# Village of Lincolnwood Zoning Board of Appeals

*Special Meeting*  
**Tuesday, November 4, 2024**  
**7:00 P.M.**

6. **Case #ZB-11-24: 7215 North District Avenue – Amendment to the Unified Sign Plan and Further Zoning Variations Pertaining to Signage Throughout the Property**  
*The hearing regarding this matter was continued on October 22, 2024.*

## District 1860 Unified Sign Plan Changes

Rev: 00 Date: 10/7/22  
Drawn by: SM  
Scale: 1:1  
SHEET: SE  
**SE**  
SOUTH ELEVATION

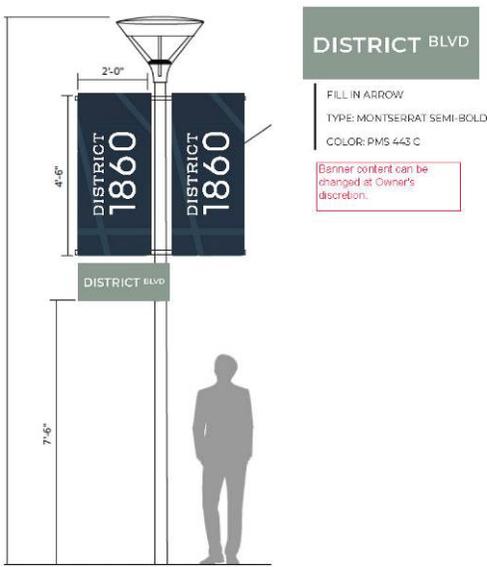
Add location "V" for the 3rd wall sign requested

LOCATION PLAN

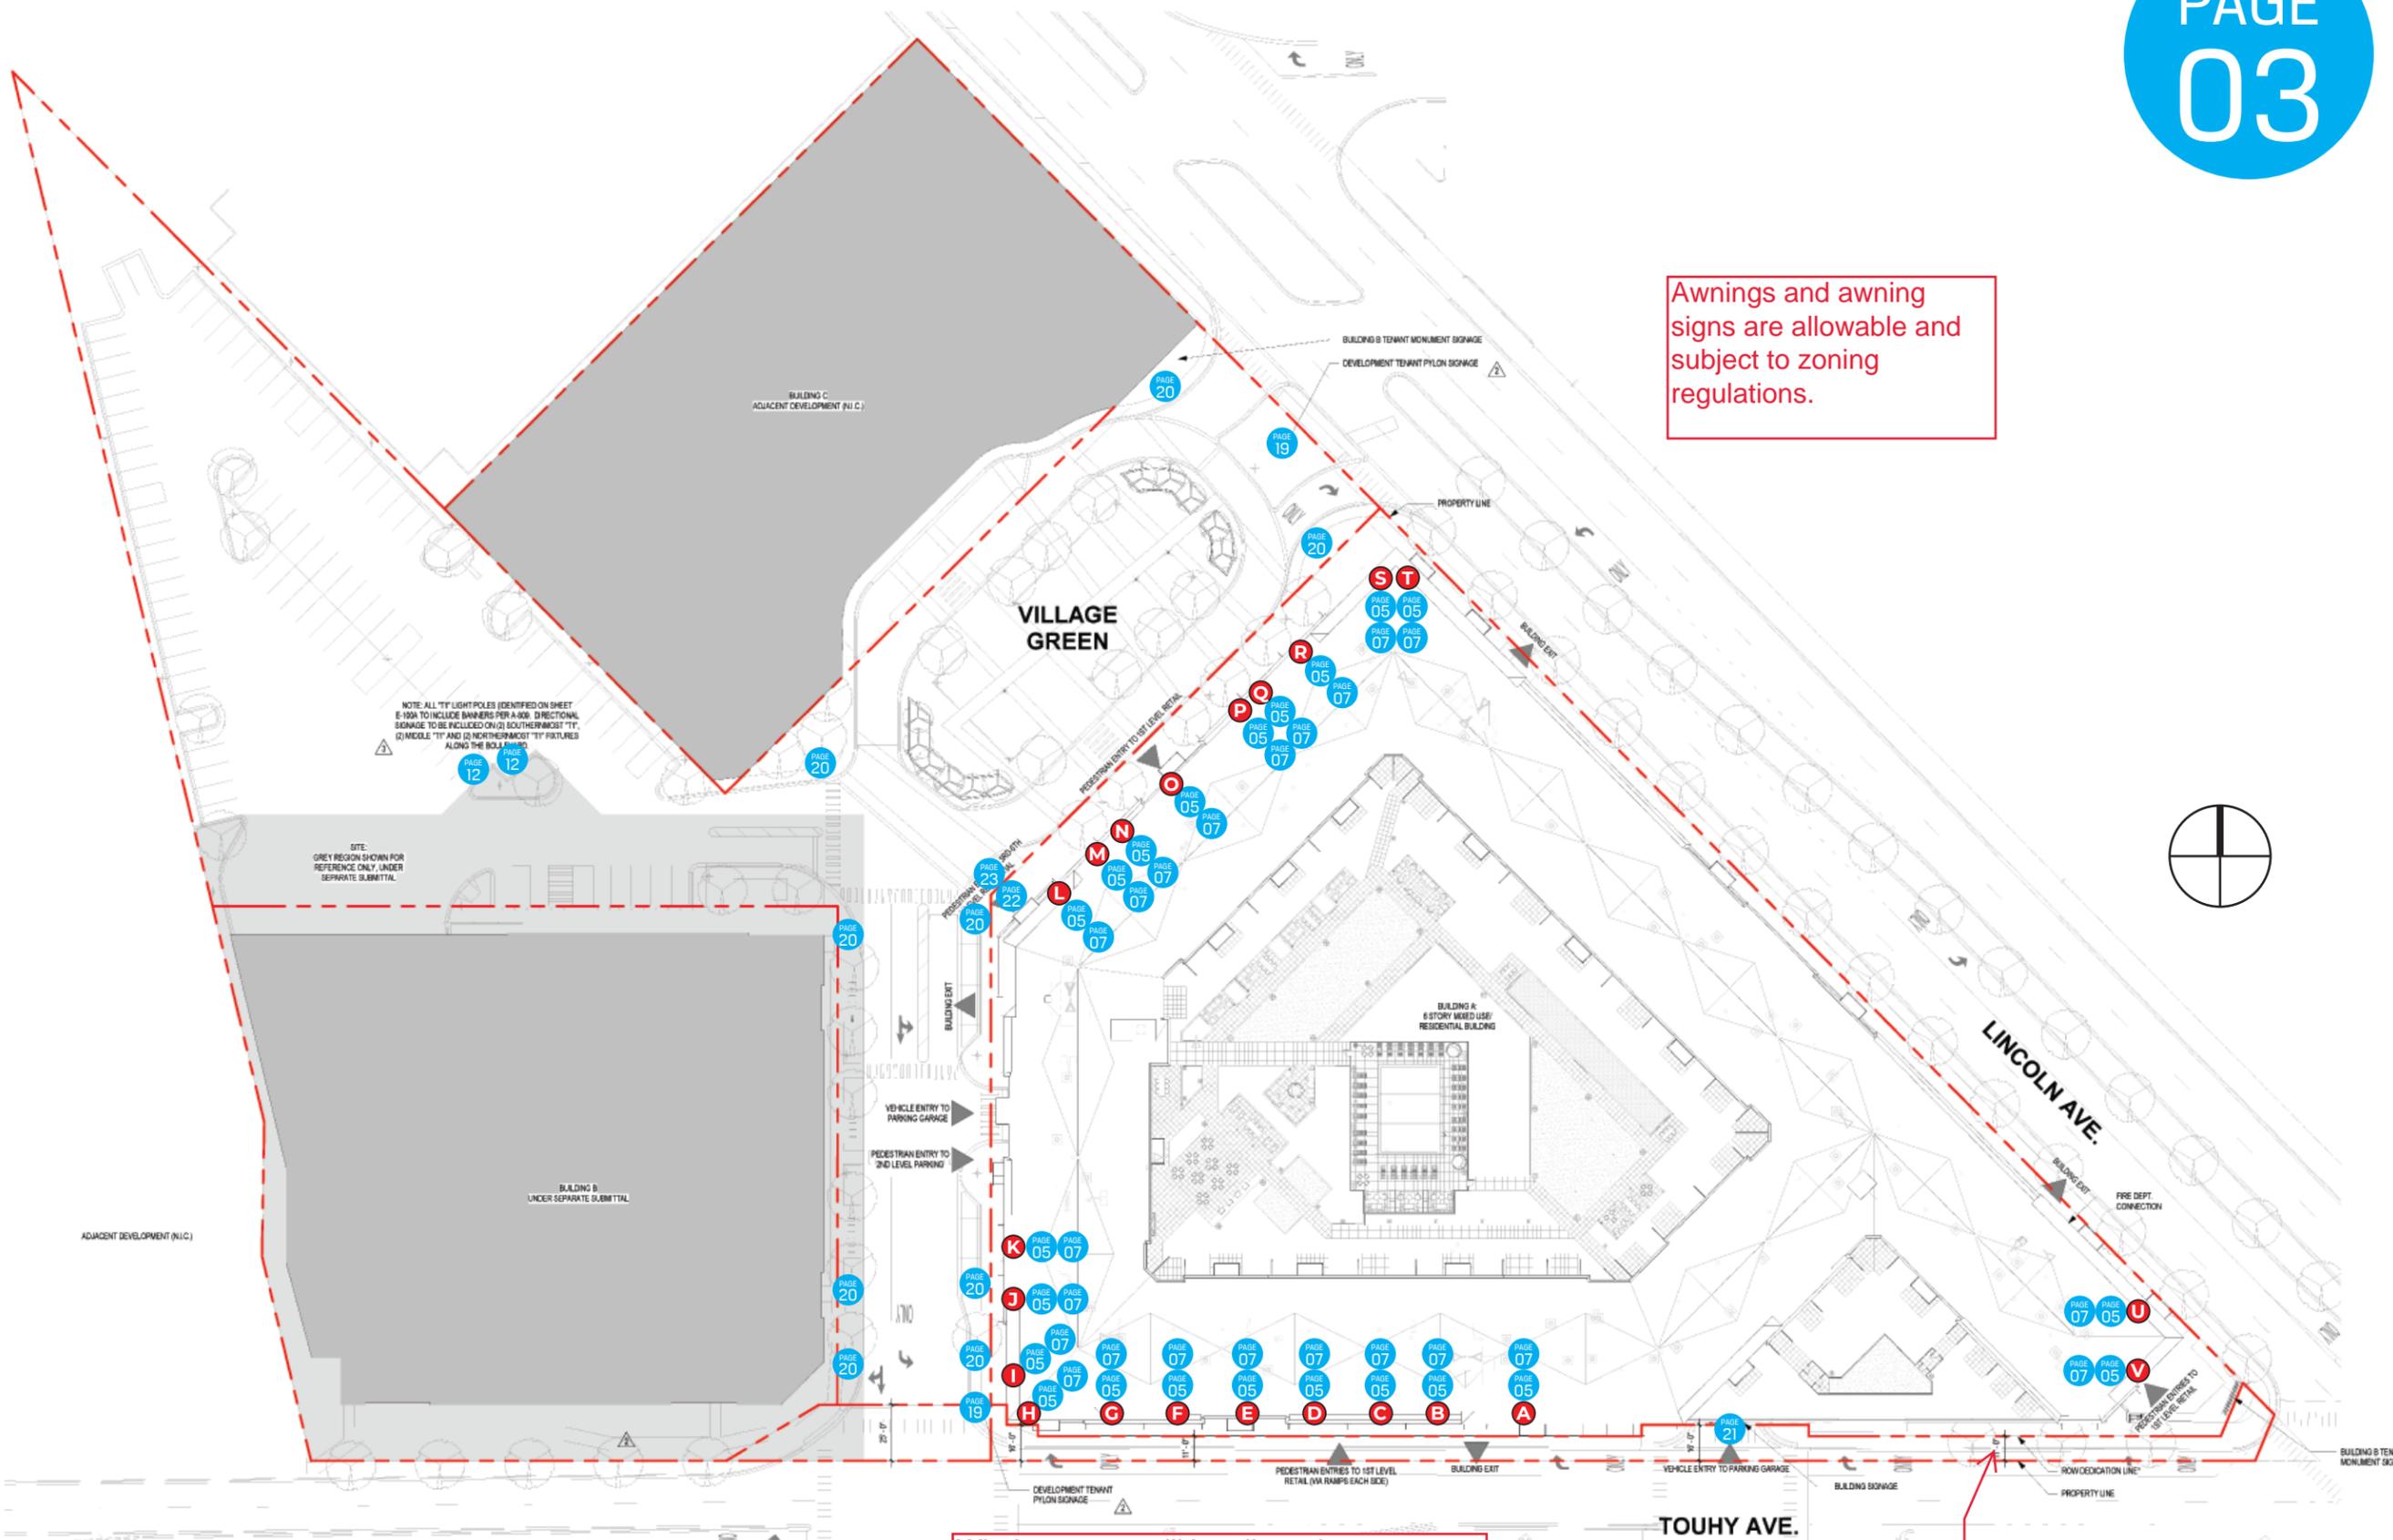
Add location for new wall sign (3rd wall sign for this tenant). "W"

TENANT SIGN SCALE: 3/4"=1'-0"

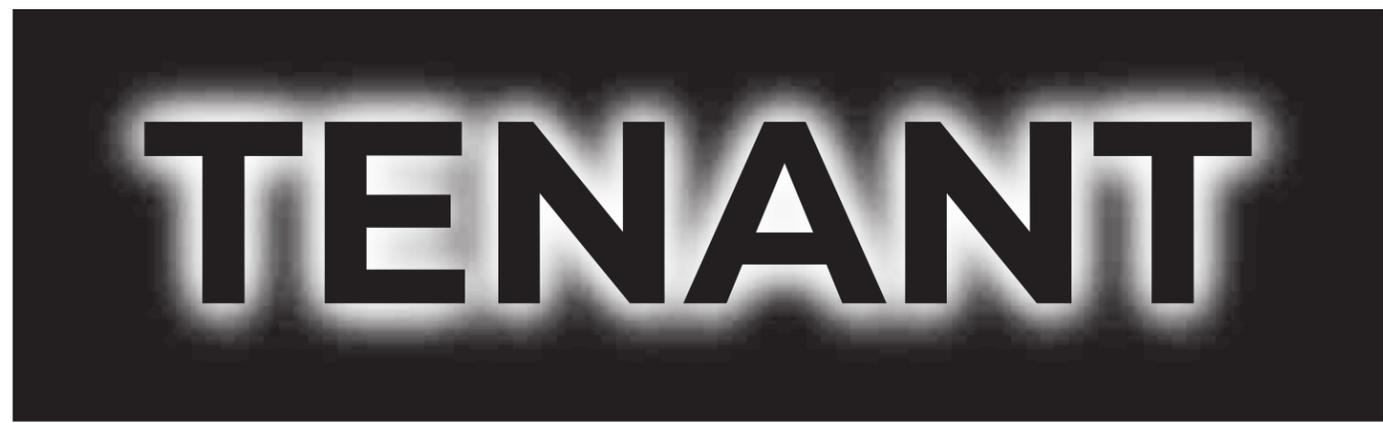
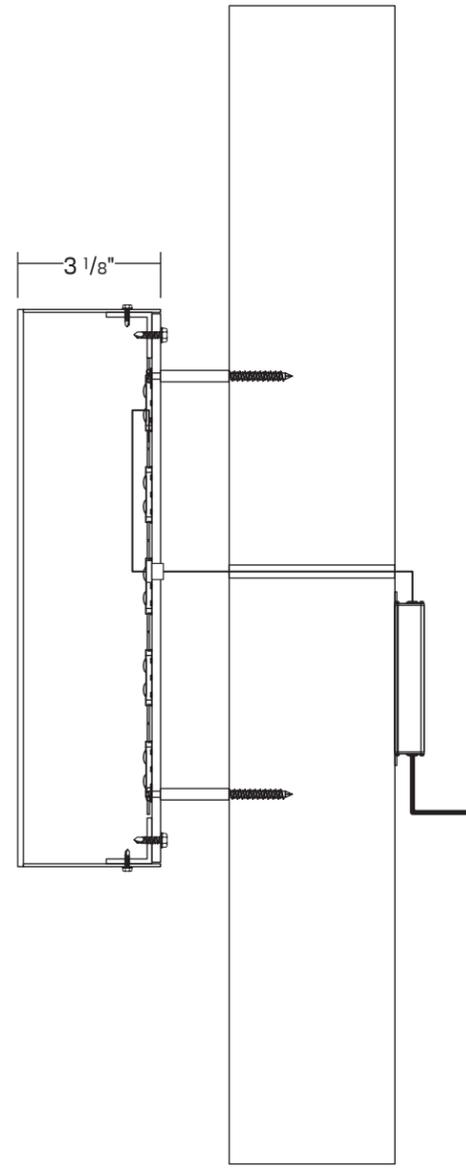
Change Min Offset from 3' to 1'

Change to "Letters and logos..."

Change Min Offset from 3' to 1'
